ADDENDUM 3

'Matilda Torres High School, Toros Stadium'
Matilda Torres High School
16645 Road 26. Madera, CA 93638

DARDEN PROJECT NO. 0622.4
DSA File Nos. 10-C3
DSA APPL. NO. 02-118396

The following additions, deletions, and revisions to the SHEETS and Project Manual are hereby made and do become a part of these Contract Documents.

AD3-A04 Refer to Sheet SD/A208

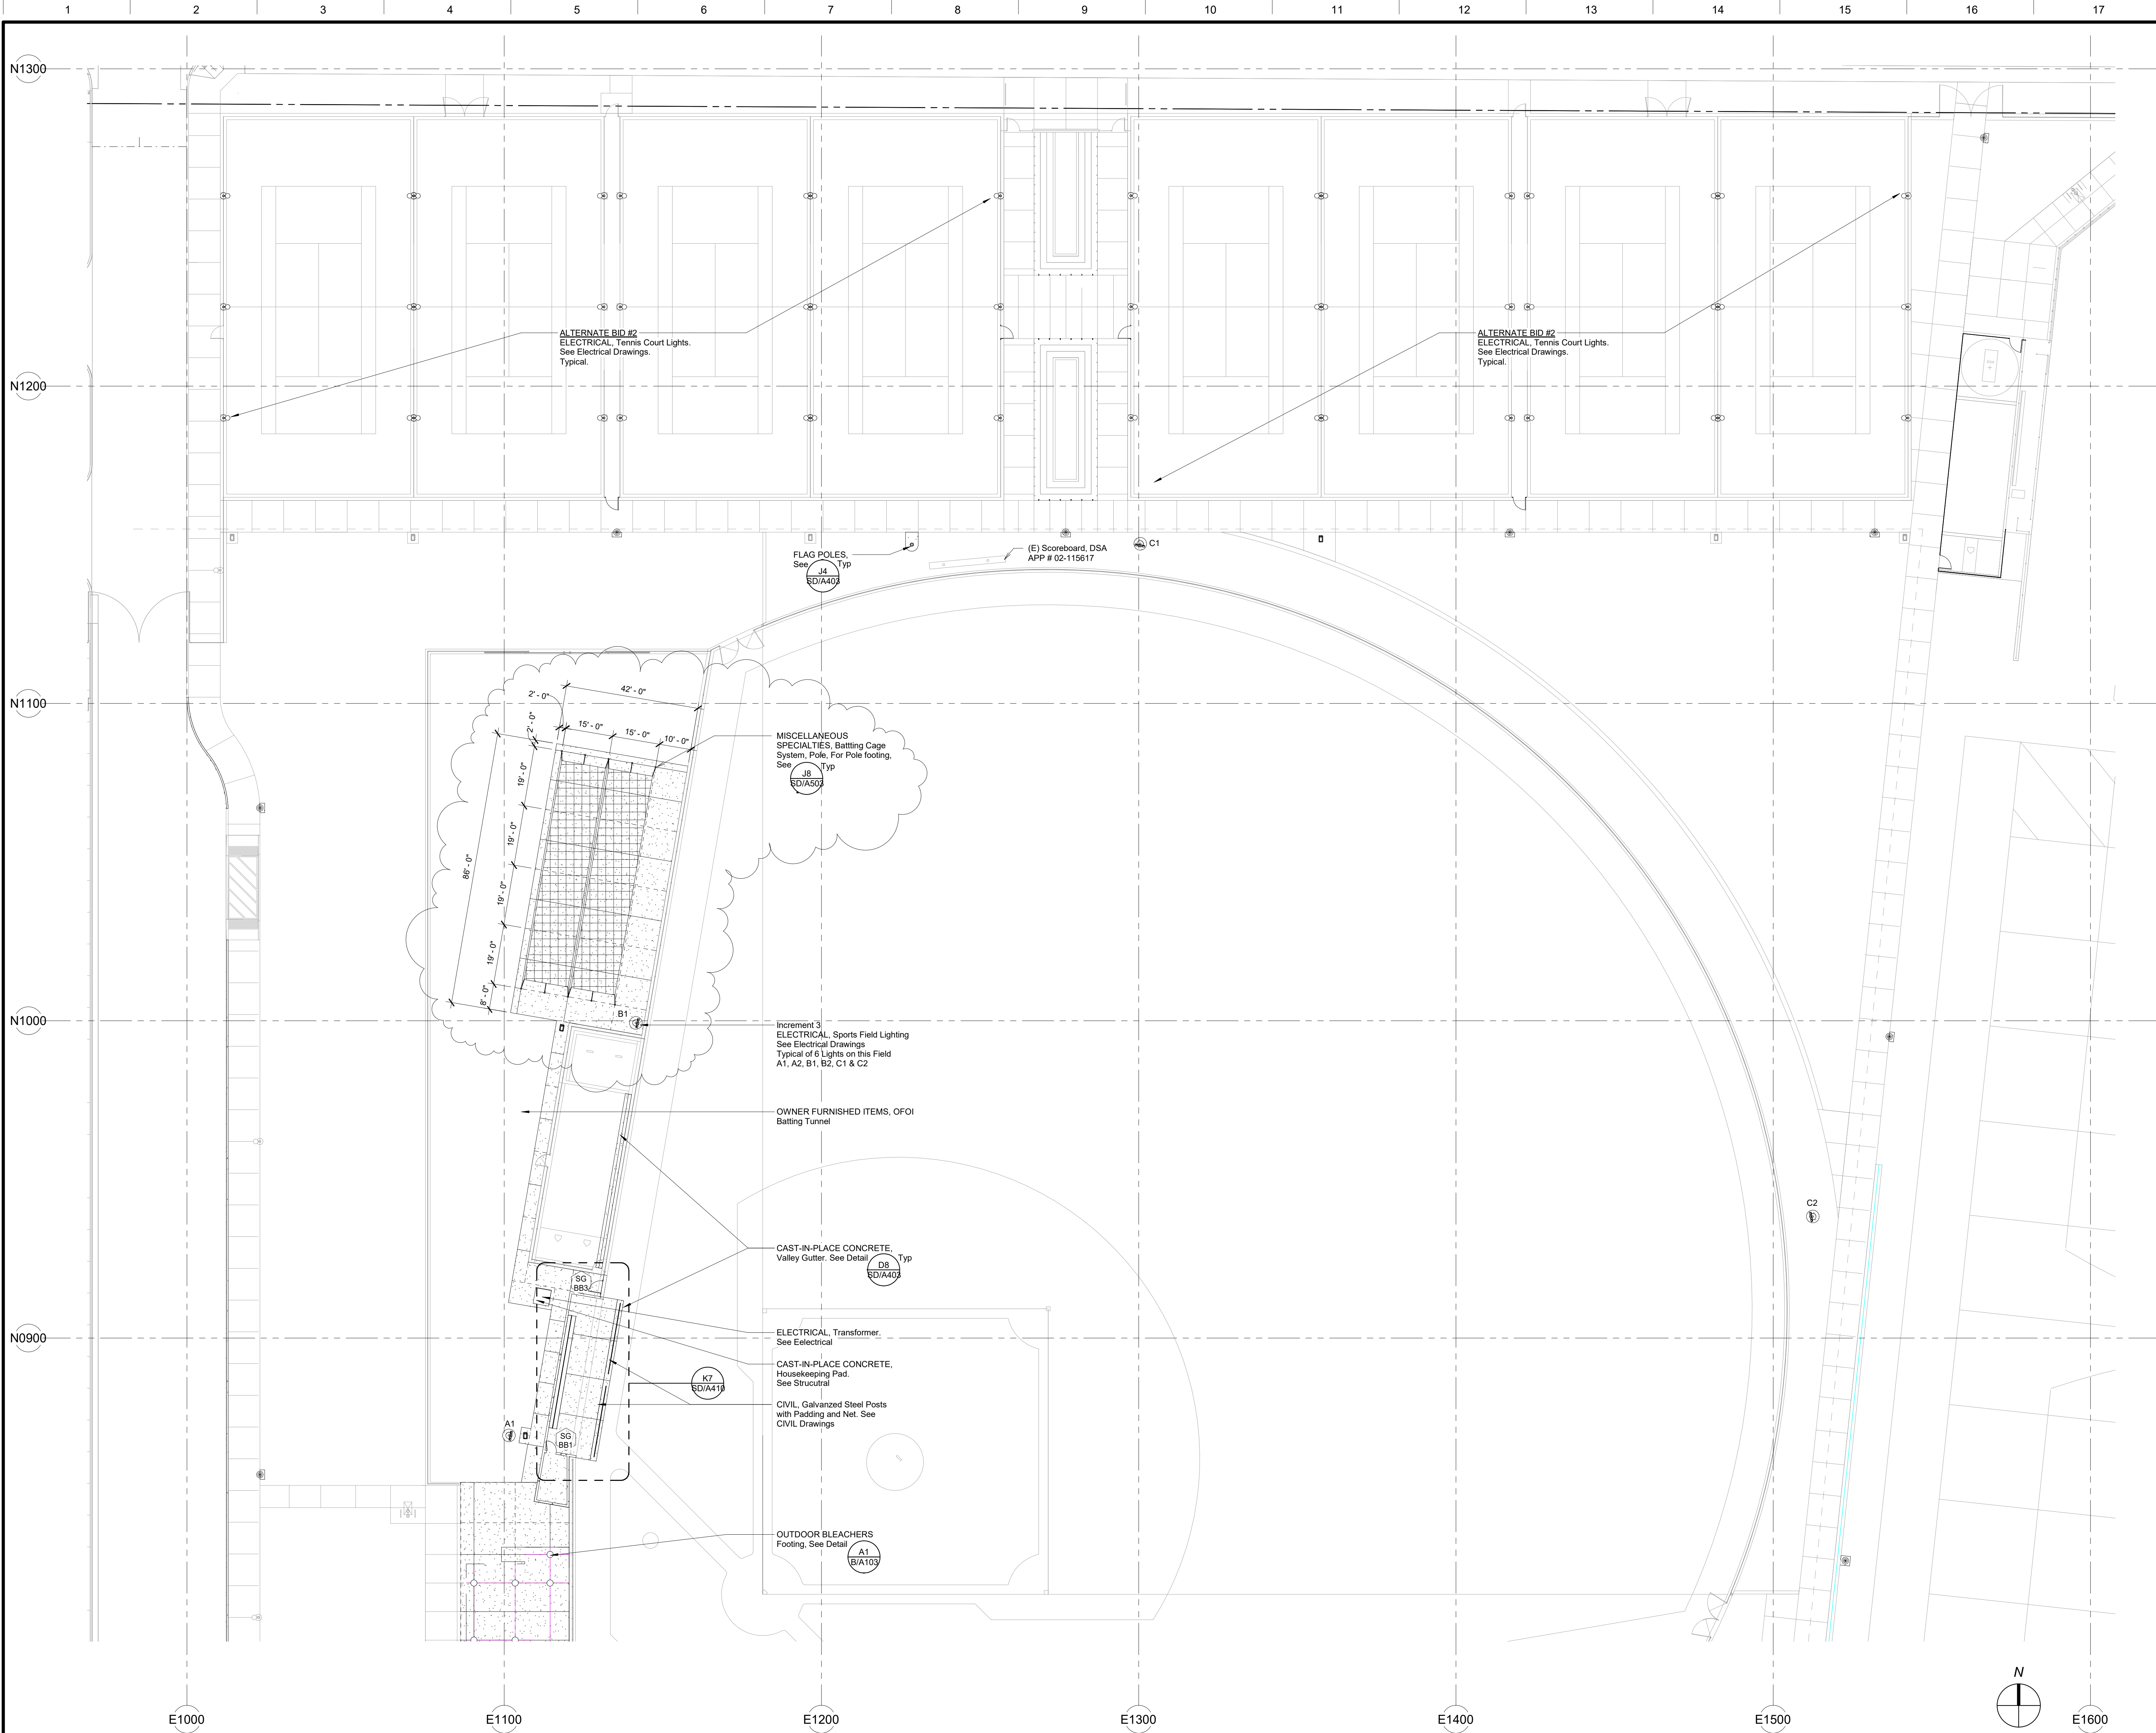
1. Revise detail callout at note indicating visitor side bleacher footings to read A1-B/A103

AD3-A05 Refer to Sheet G/000 TITLE SHEET, Site Development Drawing index

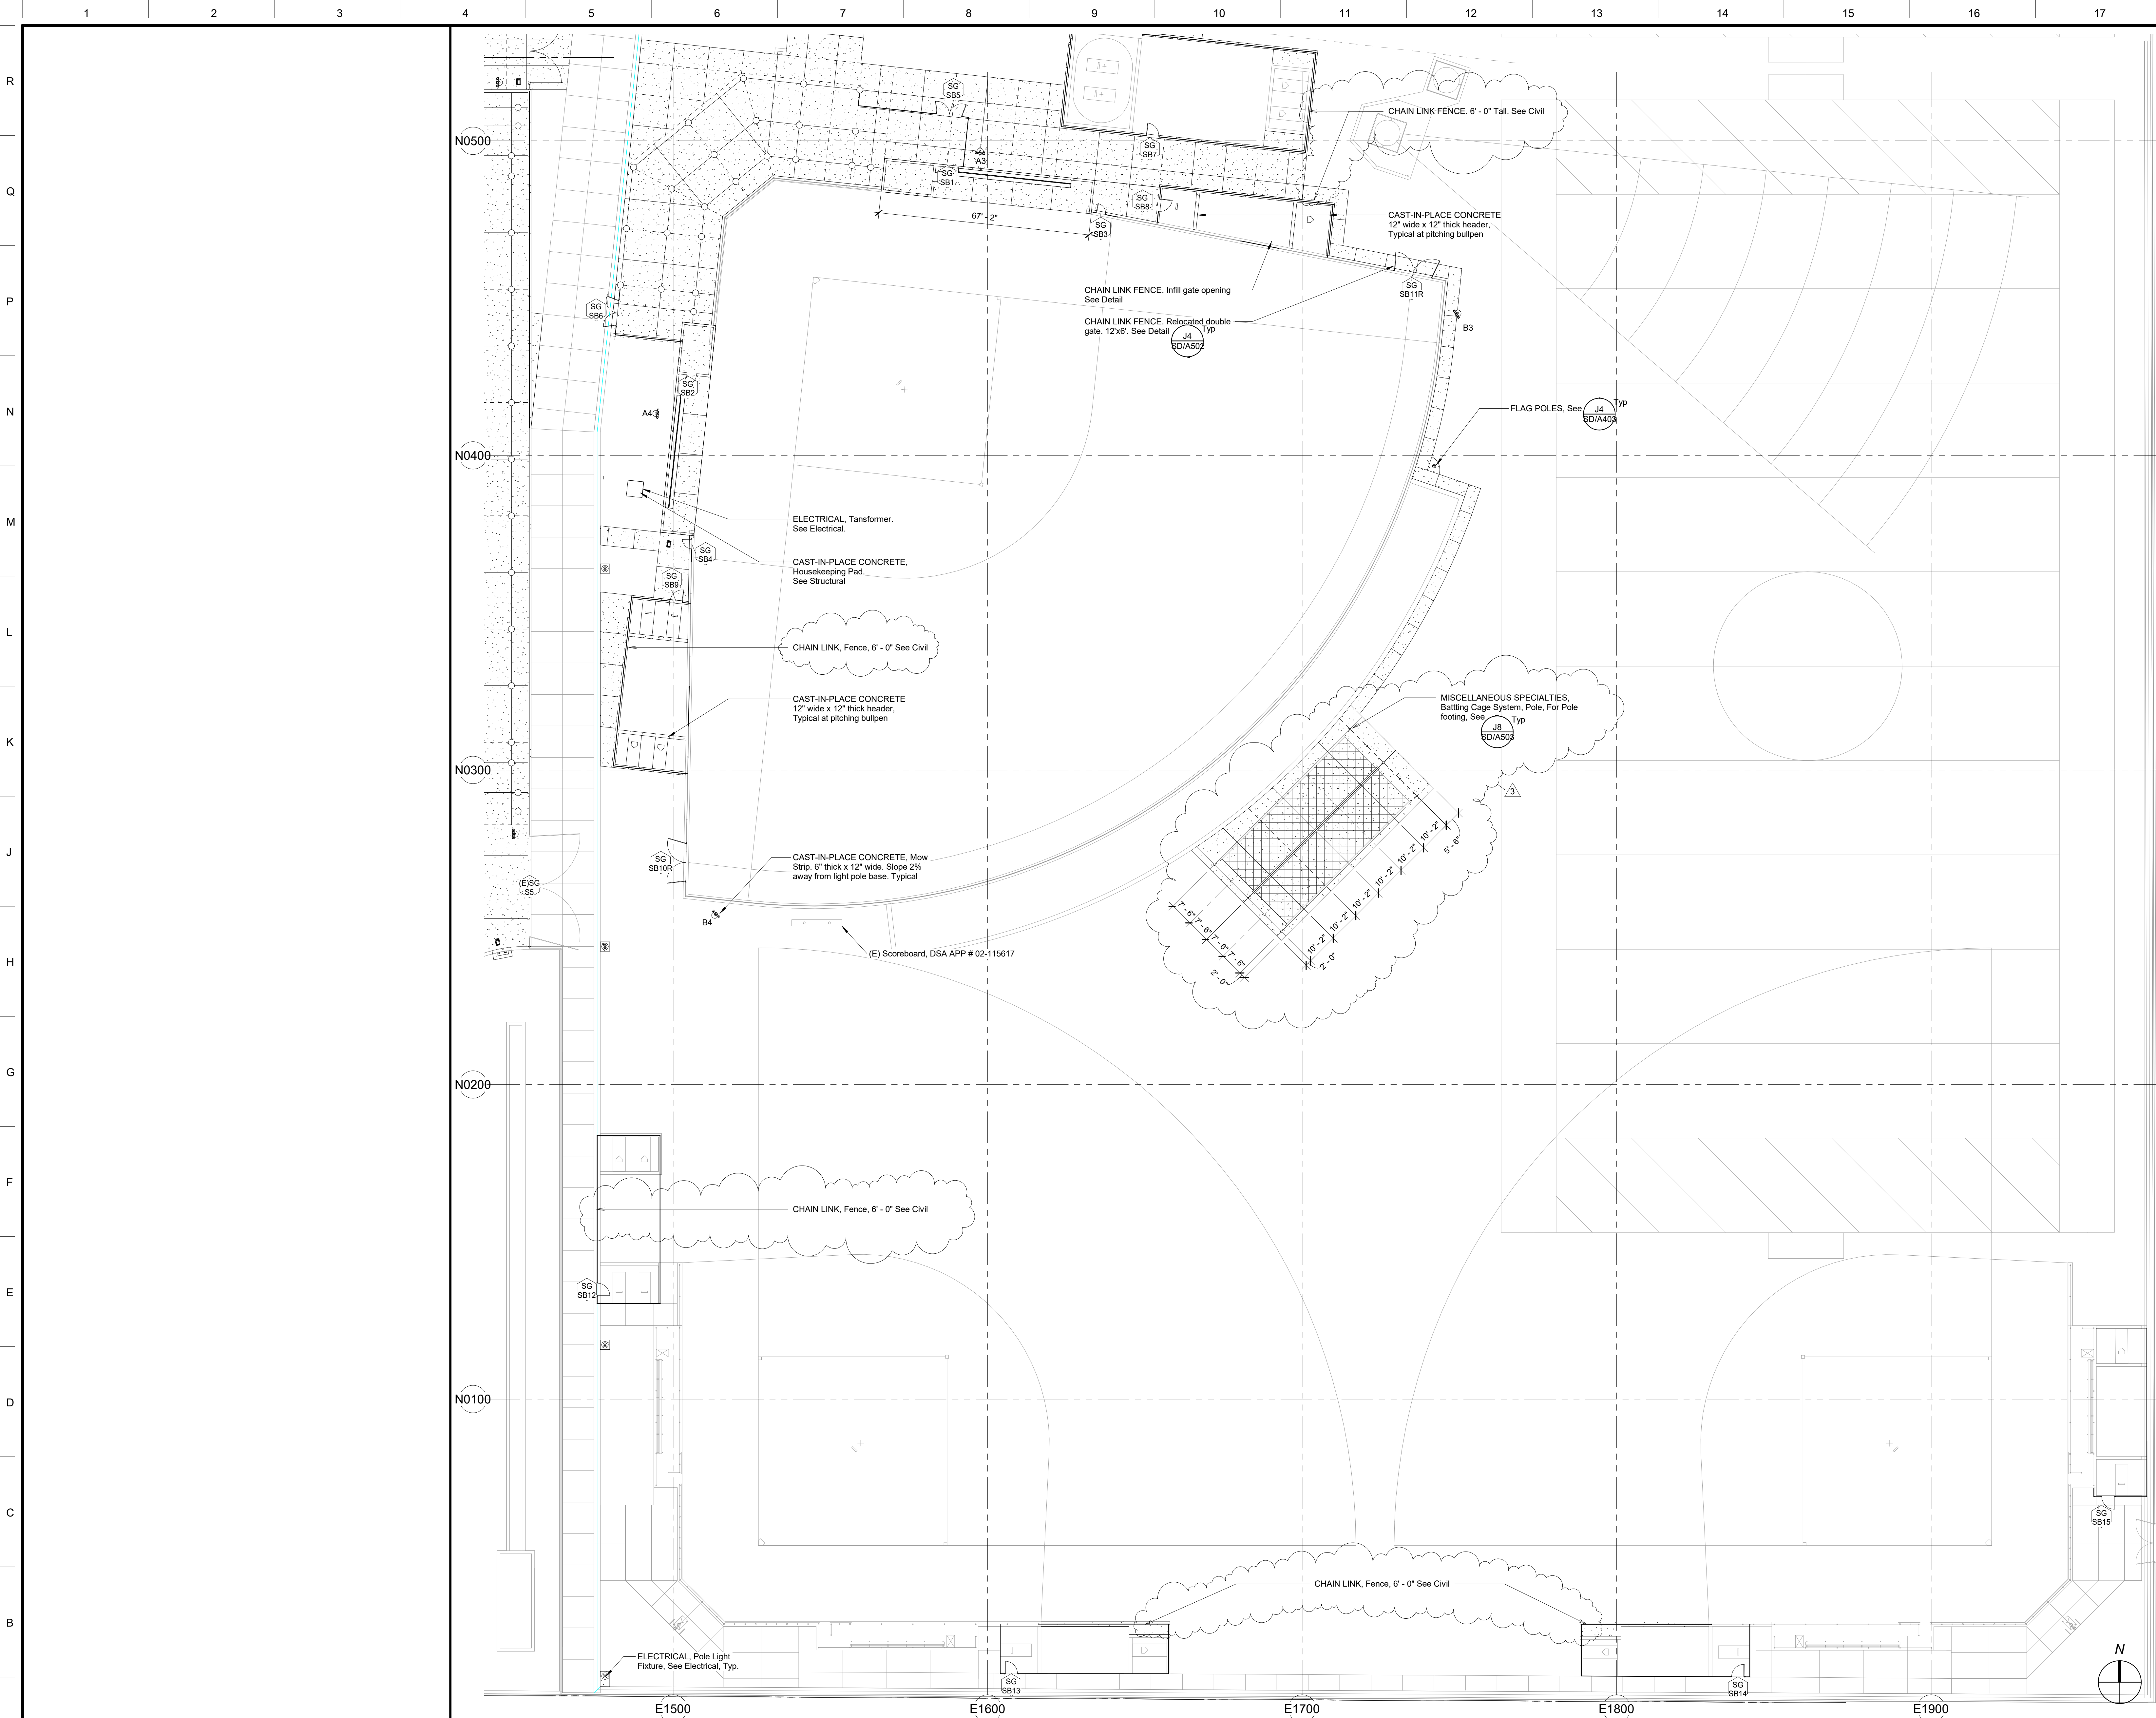
1. Strike out sheet SD/A204. Sheet is not applicable to project. Remove sheet SD/A304 from set. Do not bid scope indicated on sheet SD/A304

PARTIAL SITE PLAN - SOFTBALL

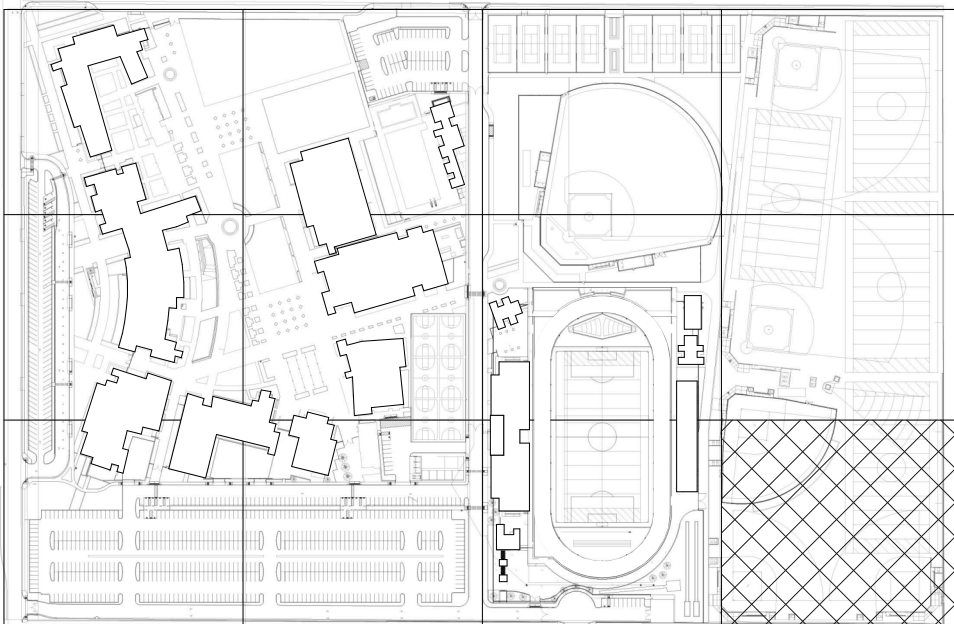
AD3-A02 Refer to Sheet SD/A212

1. Replace Sheet SD/A212 with attached sheet AD3-AX02

Batting Cage Footing Details

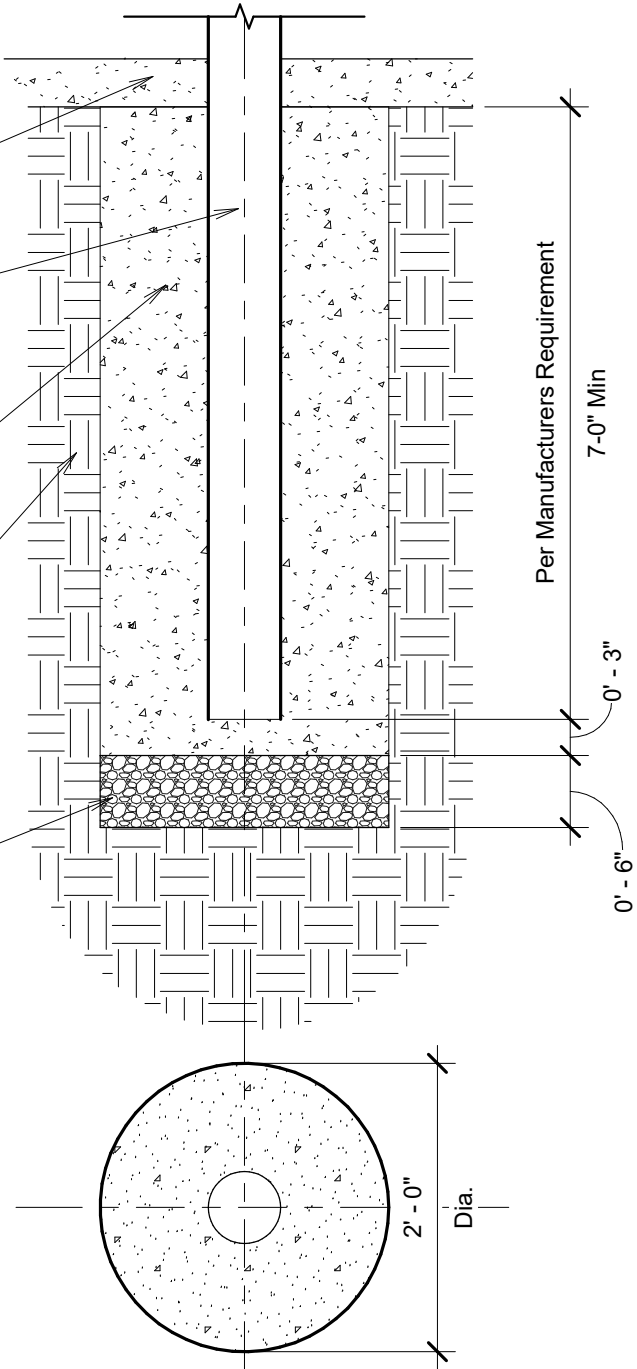
AD3-A03 Refer to Sheet SD/A503

1. Add detail J8 as shown on attached drawing AD3-AX03

MISCELLANEOUS SPECIALTIES,
Batting Cage System, Post, Typ

CAST IN PLACE CONCRETE-
Footing, 3,500psi Concrete with W/C
Max of 0.60

EARTHWORK, Prepare for
Footing as Indicated in
'Undisturbed Soils', Typ

EARTHWORK, Compacted
Crushed aggregate

MISCELLANEOUS SPECIALTIES,
Batting Cage System Post
Condition
